IBC — Egress

2015 GROUP A PROPOSED CHANGES TO THE I-CODES MEMPHIS COMMITTEE ACTION HEARINGS

2015 GROUP A – PROPOSED CHANGES TO THE INTERNATIONAL BUILDING CODE – MEANS OF EGRESS

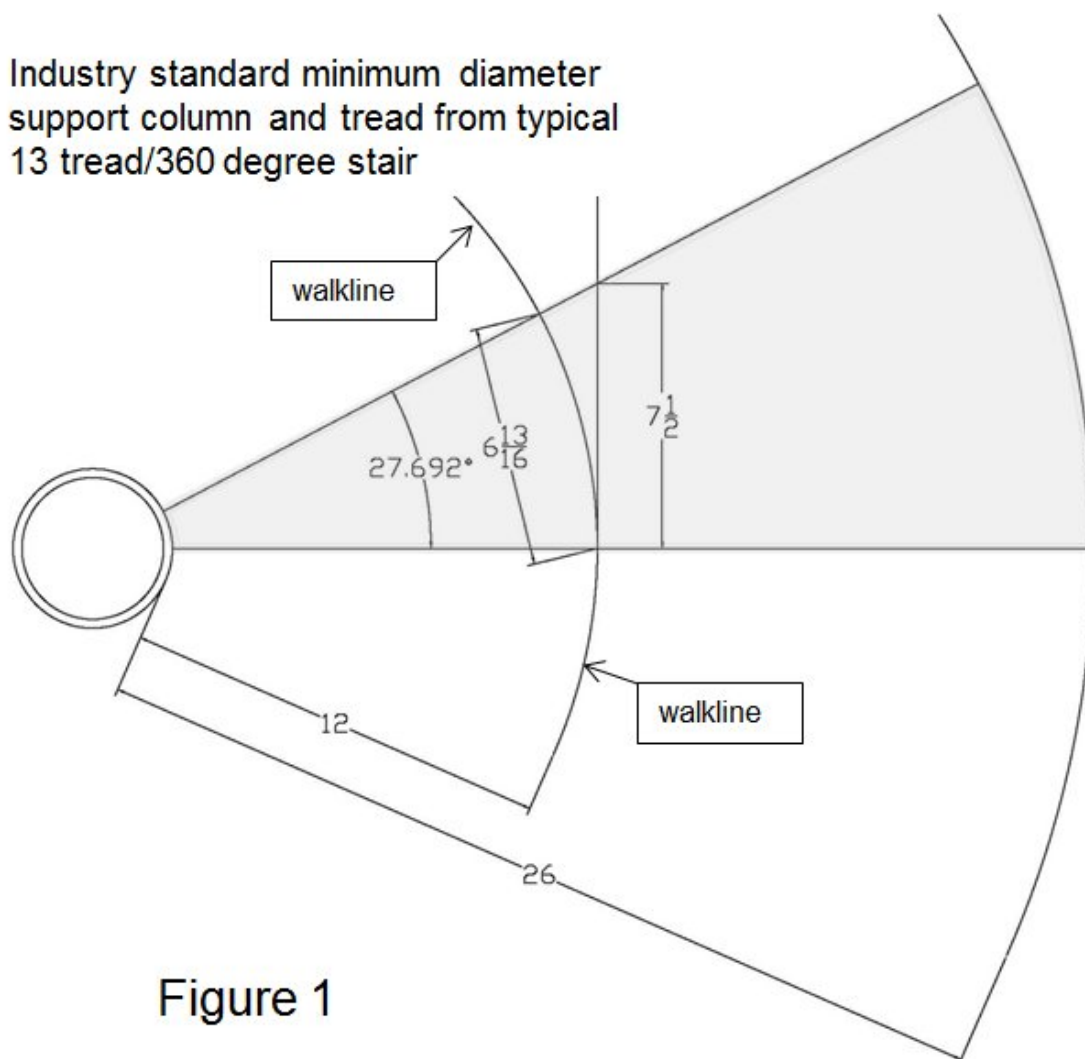
A *spiral stairway* shall have a ~~7¹/₂ - 6³/₄~~ inch (~~19¹/₂ - 171~~ mm) minimum clear tread depth at a point 12 inches (305 mm) from the ~~narrow edge~~ walkline. The risers shall be sufficient to provide a headroom of 78 inches (1981 mm) minimum, but riser height shall not be more than 9¹/₂ inches (241 mm). The minimum stairway clearwidth at and below the handrail shall be 26 inches (660 mm).

Reason: We will try again in this cycle to prevent the elimination of spiral stairways!

Winder tread depth is measured "...between the vertical planes of the foremost projection of adjacent treads at the intersections with the walkline...". The change in the method of measurement results in a smaller dimension, for the same tread, that is ³/₄ inch smaller intread depth as illustrated in figure 1. The figure also illustrates the elements of spiral stair tread geometry. What is critical to understand is that if the code is not changed, each tread in the typical spiral stairway would need to be increased by ³/₄ inch from the longstanding accepted practice.

Figure 1.A

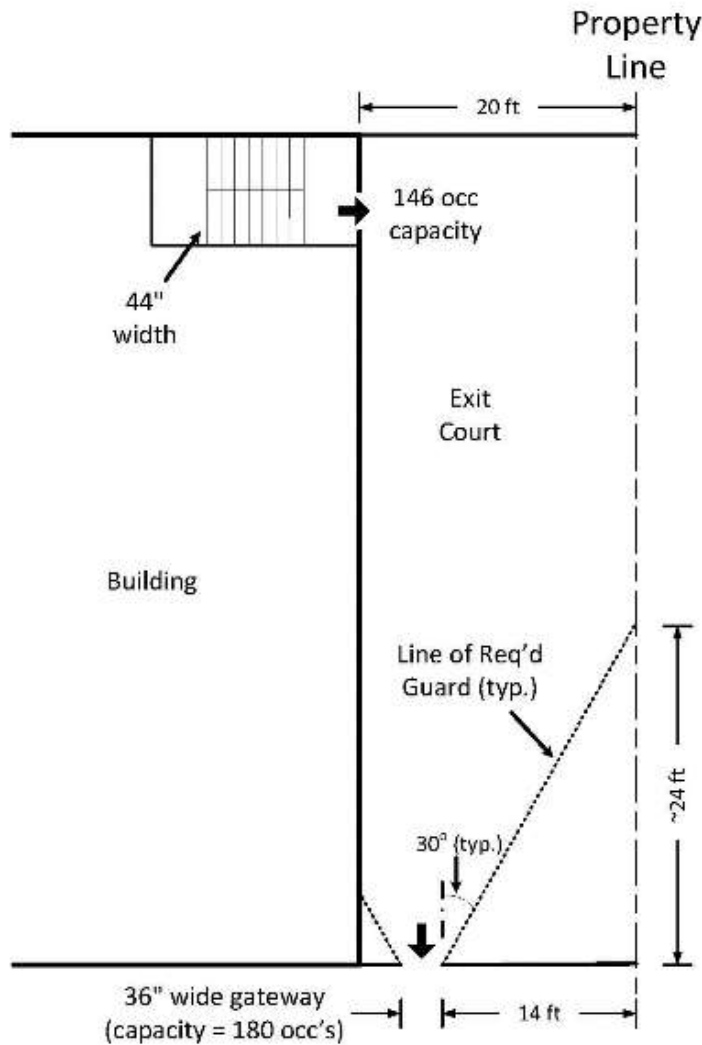
Reason: This proposal is intended to provide an alternative to the "funnel" required in exit courts. There are many cases where an exit discharges into a very wide plaza, which then has a stair or gate at one end that leads to the public way. Under the current provisions in the code, a guard of unspecified length would have to be provided to reduce the width gradually. This is regardless of the width of the plaza, the number of occupants, or the actual width of the stair or gate. Our understanding is the intent is to reduce the hazards of crushing or bottlenecks at a sudden change of width, but the hazard should be low if the actual width provided is substantially larger than required for the number of occupants.

The code also appears to assume the entire width of the exit court is a walking surface that can be used for egress purposes. In our experience, this is rarely the case. Many times, landscaping is required in side yards where the exit courts are located. The landscaping can be vegetation that is planted at the ground level, or for the plazas mentioned above, may be in raised planters. This proposal makes sure a real exit capacity is maintained when the funnel is eliminated, by specifying the walking surface must be wide enough to accommodate the required extra capacity.

Figure 1.A shows an example of how the current code can be interpreted. A stair with the minimum 44-inch width required by the code (capacity = $44/0.3 = 146$ occupants) discharges into a 20-foot wide exit court. The exit court has a 36-inch wide gateway at the front property line (capacity = $36/0.2 = 180$ occupants). The current code can be interpreted to require the width to be reduced by guards at 30 degrees as shown in the figure. If one interprets the code to say that the guard must extend from the reduced section (the 36" gateway) to the widest point of the court (20'), and taking into account a 3-foot offset of the gateway, the result is a guard that extends to a point approximately 24 feet from the front property line.

Figure 1.B

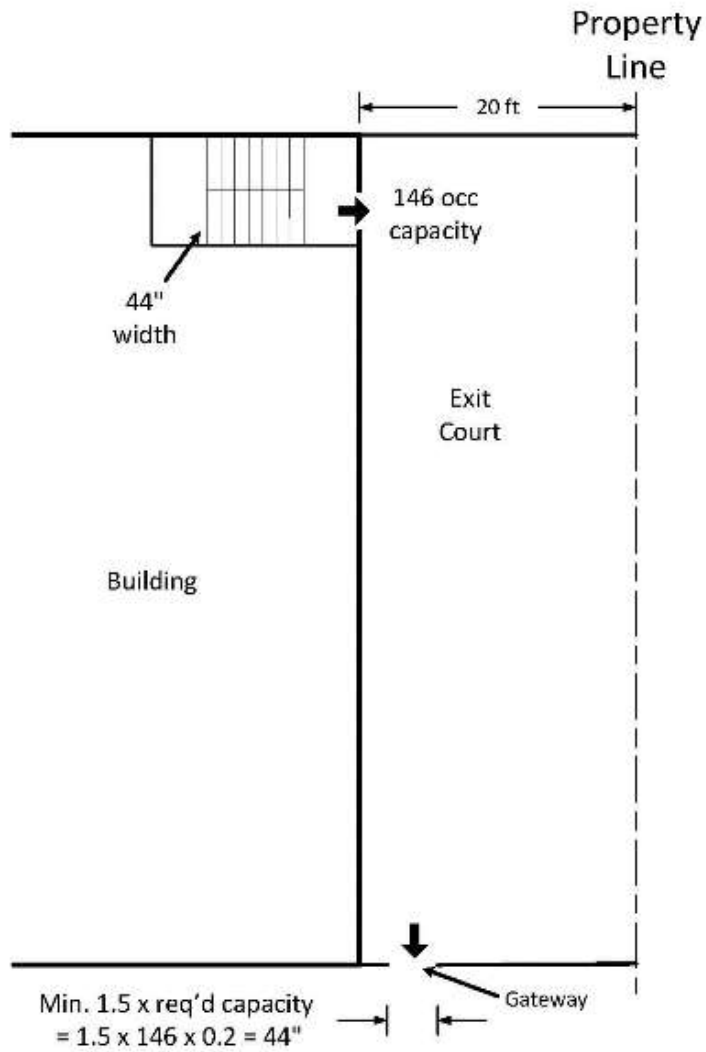
Figure 1.B shows the results if the designer opts for alternative being proposed. The gateway is now required to be 44 inches wide, but the guard is no longer required.

Figure 2.A

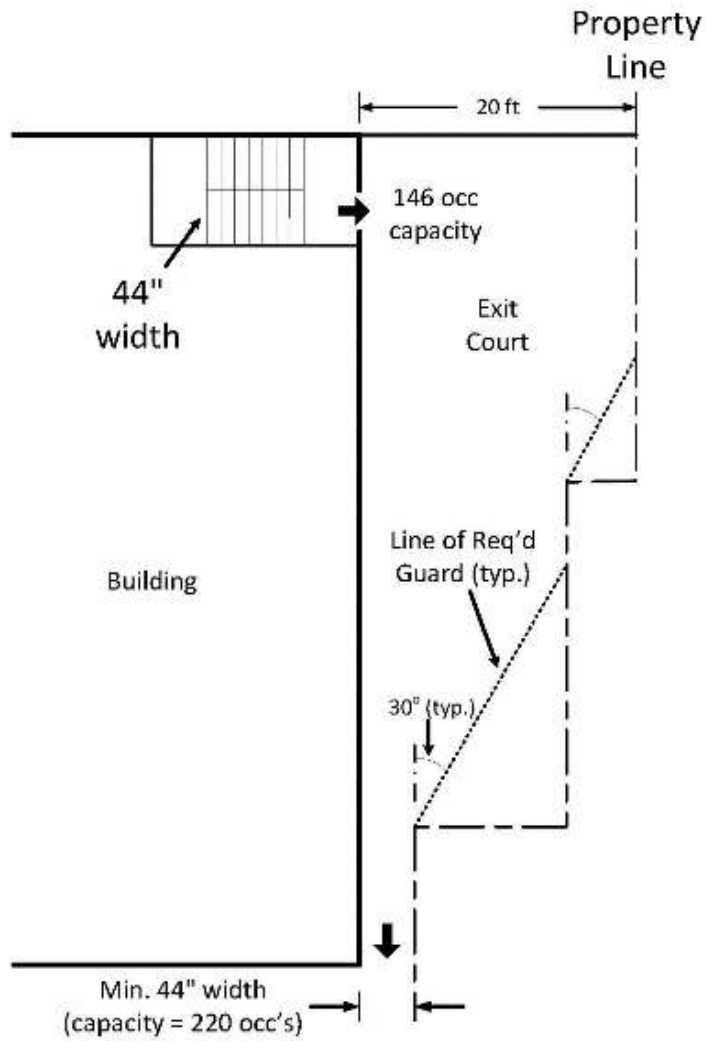
Figure 2.A depicts an exit court that reduces in width along its length and opens directly to the public way (no gateway). The same occupant load is being served by the exit court as in Figure 1.A. In this case, the code dictates a minimum 44 inch width for the exit court. The current code would clearly require the guards as shown.

Figure 2.B

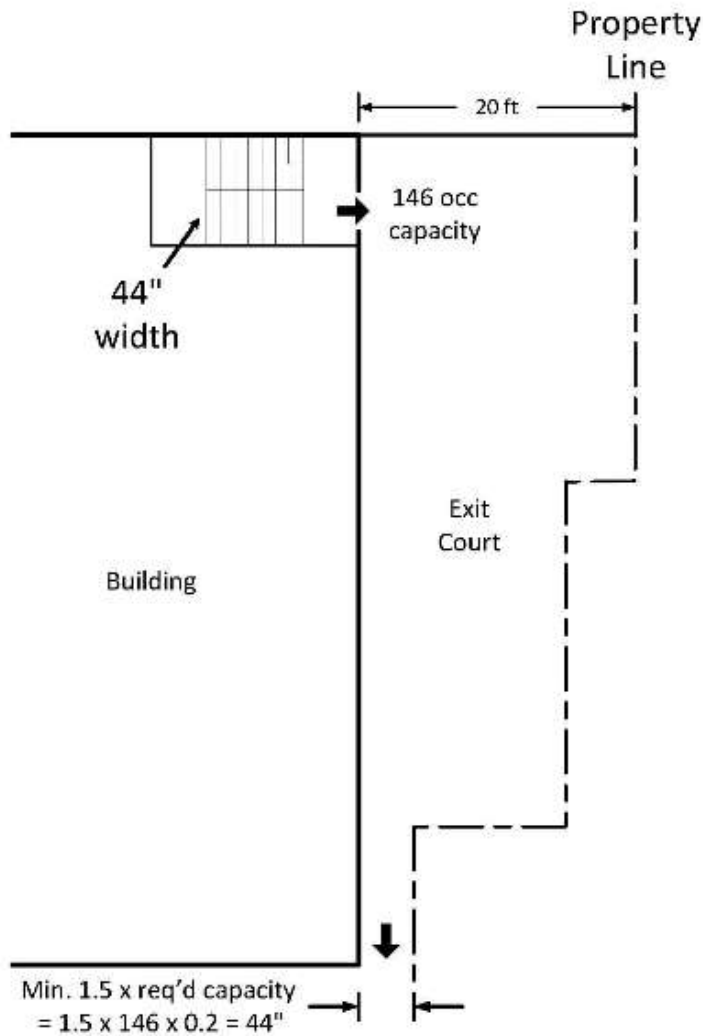
Figure 2.B shows that the minimum 44 inch exit court width required by the code would also satisfy the proposed 1.5 times the capacity requirement.
